INSPECTION REPORT  
Sedimentation Structure  
KM-B  
Kayenta Mine  
Navajo County, Arizona  
for  
PEABODY COAL COMPANY

Dames & Moore  
10139-011-22

MAXIMUM CROSS-SECTION  
A-A'  
KM-B

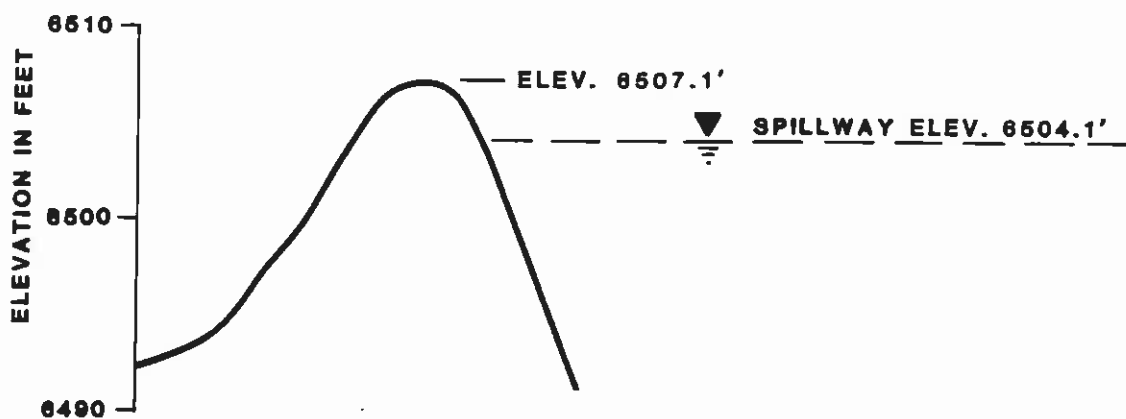
The KM-B embankment is lower in height; however, the upstream slope is steeper than the category standard; therefore, the embankment has factors of safety less than the design minimum.

The inspection of Structure KM-B indicated that the only geotechnical problem is rill and gully erosion on the upstream and downstream slope and the right and left abutments. Correction of erosion is considered a periodic maintenance task and does not require remedial action.

The upstream slope should be flattened to 2.0 horizontal to 1 vertical to meet stability requirements.

CHANNEL PROFILE B-B'  
KM-B

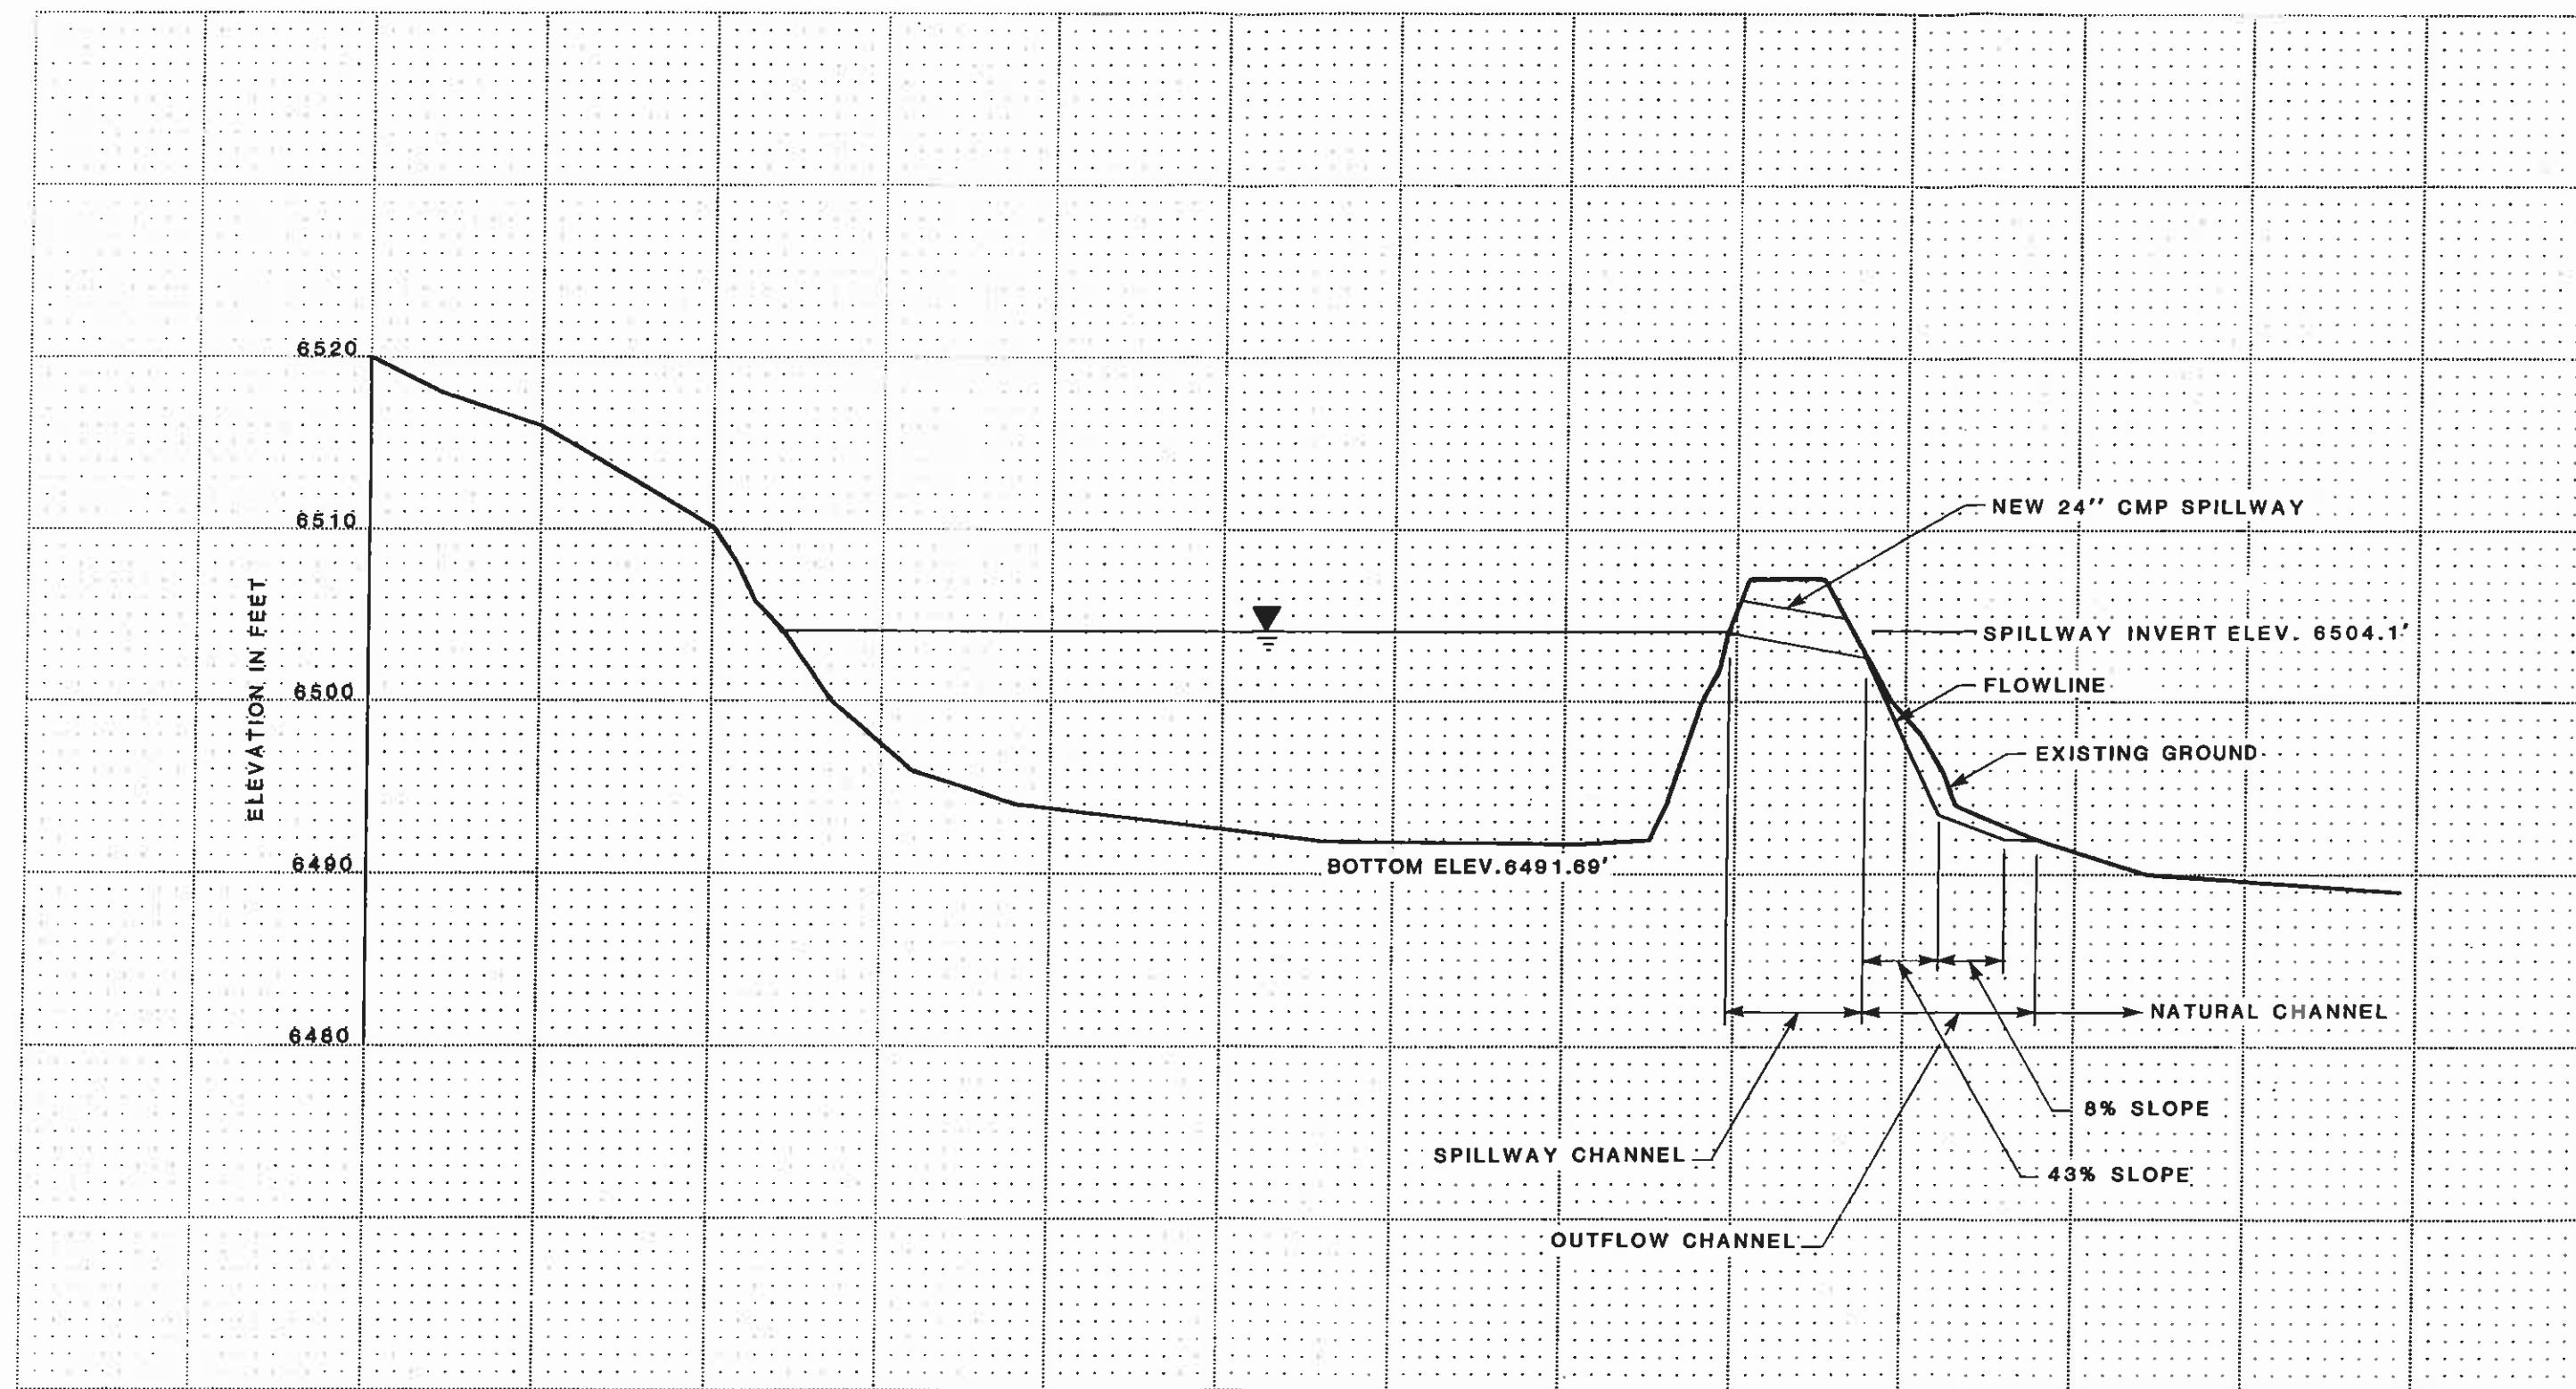
The storage capacity and spillway capacity of Structure KM-B are adequate; however, the spillway does not have an adequate outflow channel or adequate erosion protection. There is no suitable location for an improved outflow channel along the existing alignment. Therefore, a new pipe spillway and outflow channel should be constructed along the alignment B-B' shown in Plate 1. The existing spillway should be abandoned. The spillway and outflow channel profile is shown in Plate 4 and the required dimensions are shown in Plate 5. The outflow channel should be protected against erosion using geotextile and riprap as shown in Plate 5. A trashrack should be installed on the inlet of the CMP to prevent clogging of the spillway.
